NUCLEAR REGULATORY COMMISSION

[Docket Nos. 50-361 and 50-362]

Southern California Edison Company, Et Al., San Onofre Nuclear Generating Station, Units 2 and 3; Issuance of Director's Decision Under 10 CFR 2.206

Director's Decision Under 10 CFR 2.206

Figure 1

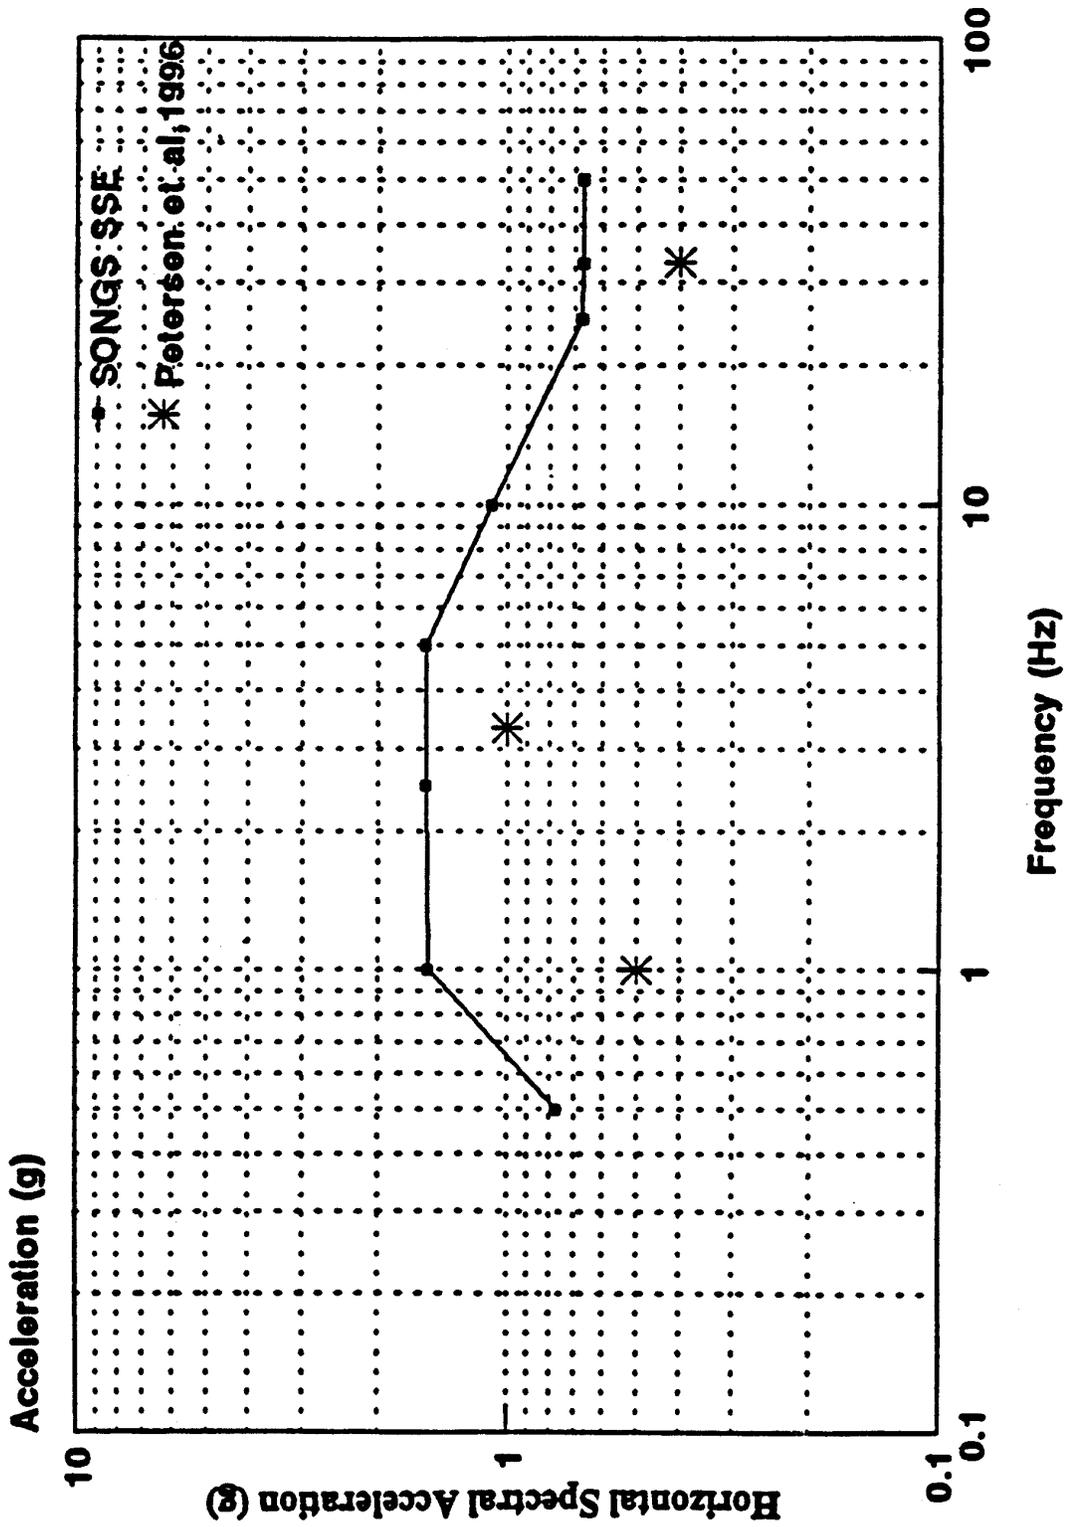
M. D. Petersen et al. (Seismic Hazard Analysis, AEG, 1-20-96)" and stated that it concludes that the entire Los Angeles, Ventura, and Orange Counties are high hazard areas. The Petitioner stated that the paper also concludes that accelerations of 0.4g (pga), 1.0g (0.3-sec SA), and 0.5g (1-sec SA) can occur nearly everywhere.

The three maps show similar hazard patterns that indicate high hazard over the entire tri-county area. The expected peak accelerations exceed 0.4g (pga), 1.0g (0.3 s SA), and 0.5g (1 s SA) nearly everywhere in the tri-county area."¹⁷

To address the acceleration values mentioned by the Petitioner with respect to SONGS, the NRC staff has produced Figure 1, which contains a plot of the SONGS SSE seismic response spectrum at 5 percent of critical damping and the values quoted from the Petersen paper. Since period in seconds is the reciprocal of frequency in Hertz, the 1-second period spectral acceleration (0.5g) is plotted at a frequency of 1 Hertz, the 0.3-second period acceleration (1.0g) is plotted at a frequency of 3.33 Hertz and the peak

ground acceleration (0.4g) is plotted at a frequency of 33 Hertz. The figure demonstrates that the spectral accelerations (accelerations plotted in the response spectra) used in the design of SONGS are significantly higher than those from the Petersen paper, thus showing the conservatism of the design basis for SONGS.

Figure 2

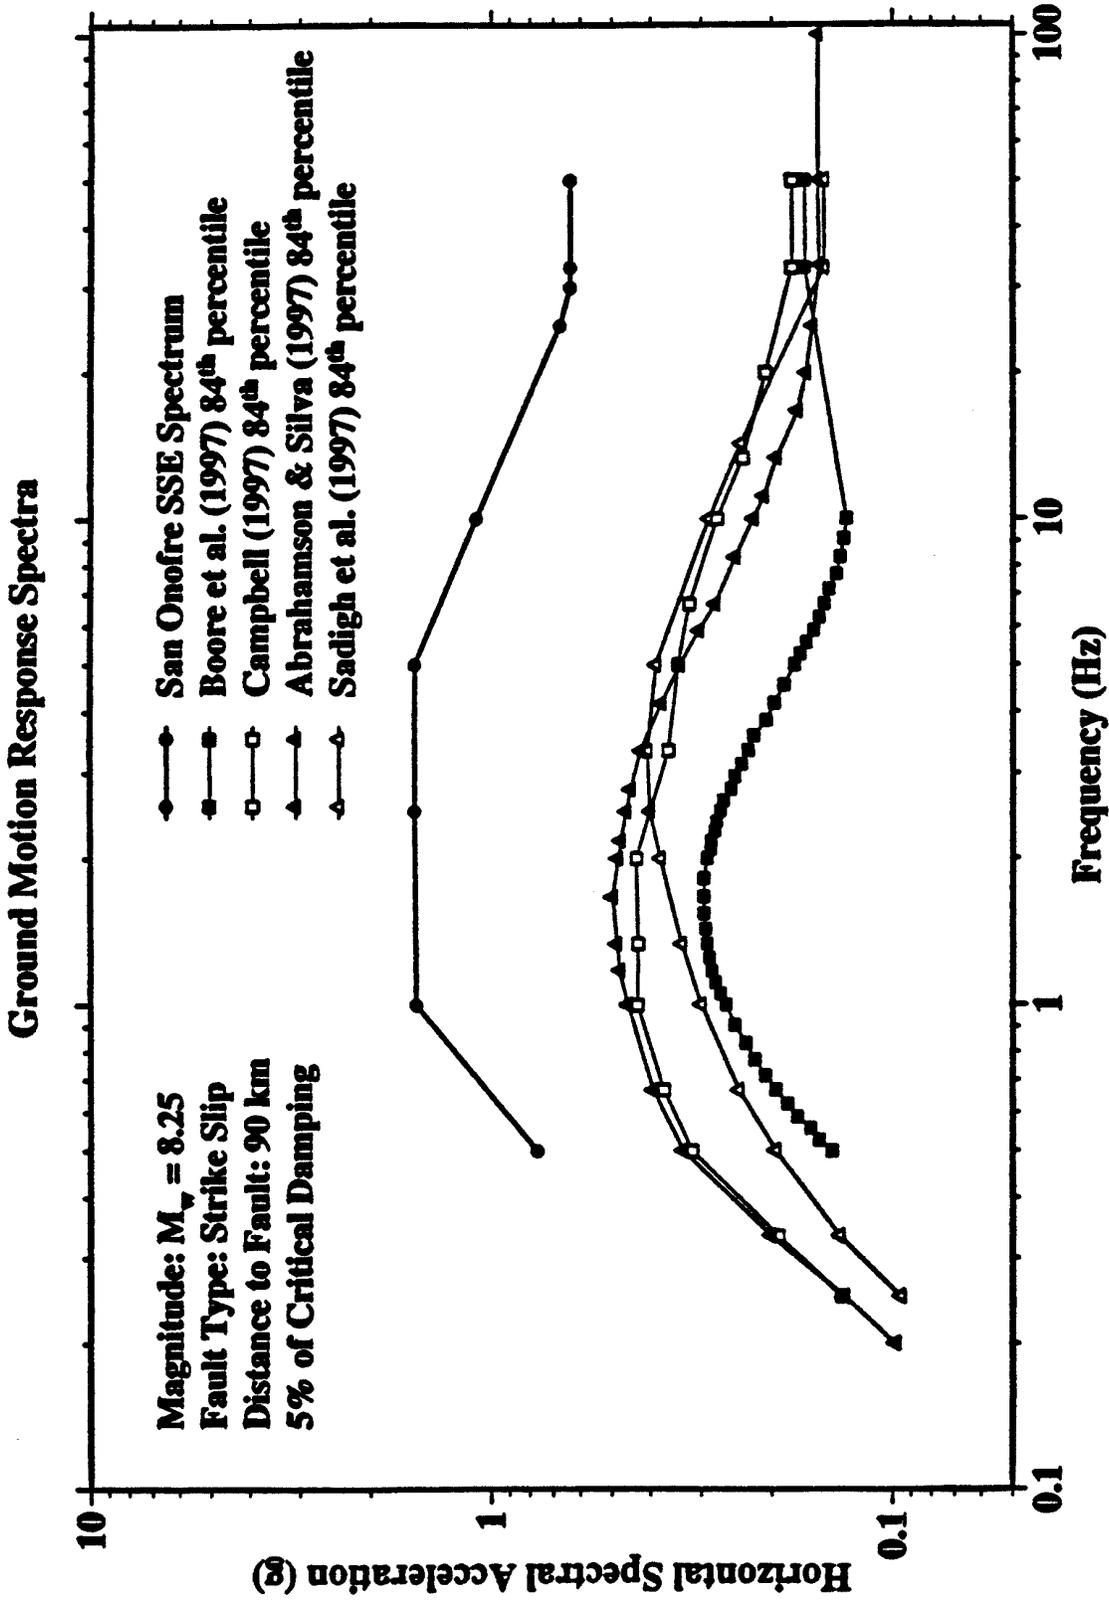
In the enclosure to his letter dated December 10, 1996, entitled "Uncertainty Factors Affecting Seismic Risk Risk Modelling in Southern California," the Petitioner stated "We must prepare for a great event on the Southern San Andreas Fault." He also mentioned an earthquake on the San Andreas in his e-mail message.¹⁸

The NRC staff agrees that there must be preparation for a large event on the San Andreas fault and finds that the SONGS seismic design is well able to withstand the demands of a large earthquake on the southern San Andreas fault. Although the geologic evidence appears to indicate that the largest event to have occurred on the southern San Andreas in the Quaternary Period (the last 2 million years) is estimated to have been in the moment magnitude (M_w) range of 7.5 to 8; to evaluate the potential ground motion at the SONGS site from a large earthquake on the southern San Andreas fault, the staff made the very conservative assumption of a moment magnitude 8.25 strike-slip earthquake at the closest distance of the San Andreas fault to the site (90 kilometers). This assumption was made to calculate the effects of a large earthquake on the San Andreas fault. The results are plotted in Figure 2 which demonstrates that the design basis (SSE) spectrum for SONGS is much higher than the ground motion estimates from the M_w 8.25 on the San Andreas fault using four recent attenuation relationships. These four empirical attenuation relationships were developed after the occurrence of the Northridge and Landers earthquakes, and include the recent strong ground motion from these events. They were performed by internationally known experts in earthquake ground motion analysis and were published in the *Seismological Research Letters*,¹⁹ the peer-reviewed journal of the Seismological Society of America. The assumption of a moment magnitude 8.25 strike-slip earthquake and the

SONGS site foundation geology were used as input parameters for these four earthquake ground motion attenuation relationships.²⁰ The ground motion estimates were made at the 84th percentile level recommended by SRP Section 2.5.2. The plots of the results obtained from these four attenuation relationships and the SONGS Units 2 and 3 SSE design response spectrum are shown in Figure 2. The plotted information in the figure demonstrates that the SONGS design is well able to accommodate the demand of the ground motion of the large earthquake on the southern San Andreas fault since it envelopes the estimates of the four relationships at all frequencies.

Figure 3

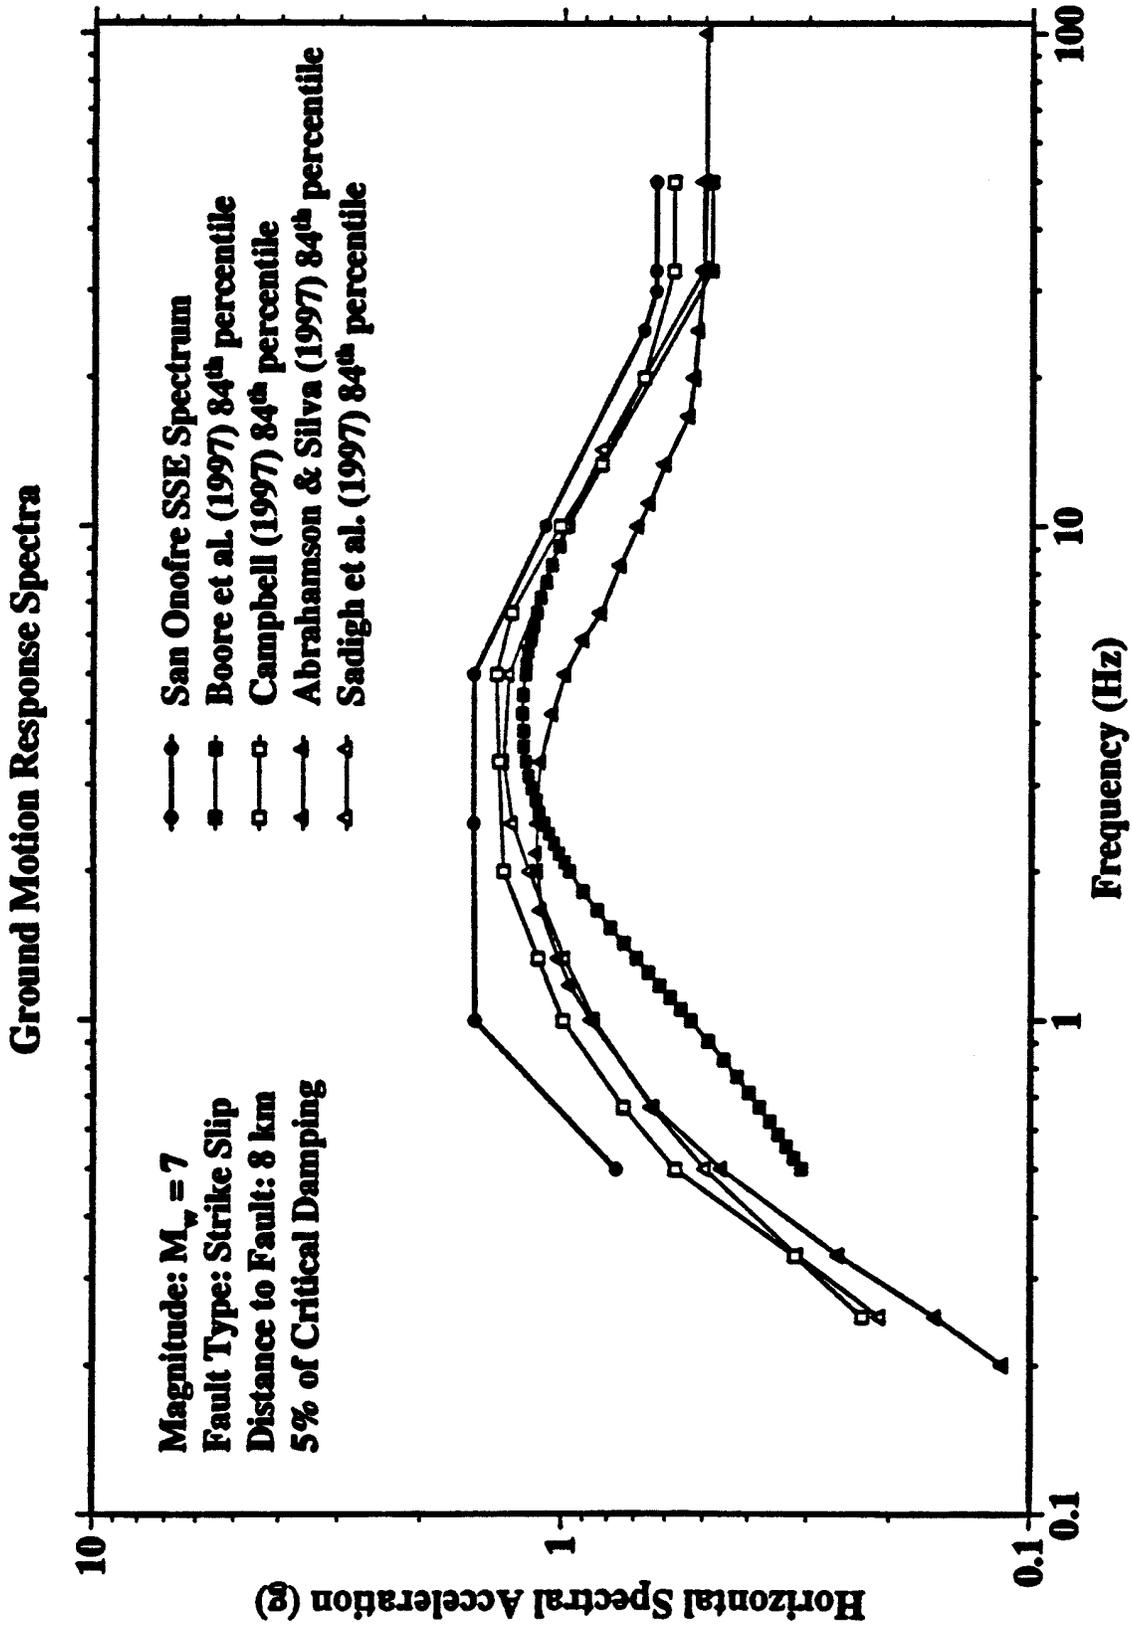
Campbell and Bozorgnia³⁴ used 167 accelerograms recorded during the Landers earthquake to study the ground motions from this event. A comparison of these recordings with ground motions predicted by contemporary attenuation relationships indicated that relationships developed before the Landers earthquake made a reasonable prediction of the Landers ground motions within 60 kilometers of the fault, and relationships developed after

the Landers earthquake did a reasonably good job of predicting the Landers ground motions within the distance ranges for which they were applicable. This information shows that there was nothing extraordinary about the ground motions from the Landers earthquake that would challenge the adequacy of the near field ground motion estimates made for the SONGS SSE. To demonstrate the adequacy of the SONGS SSE ground motion, Figure 3 contains a plot of the SSE response spectrum and the 84th percentile response spectra obtained from the four recent earthquake ground motion attenuation relationships to estimate the ground motion for a magnitude M_w 7 earthquake at a distance of 8 kilometers. The SONGS response spectrum envelopes the response spectra of all four relationships at all frequencies.
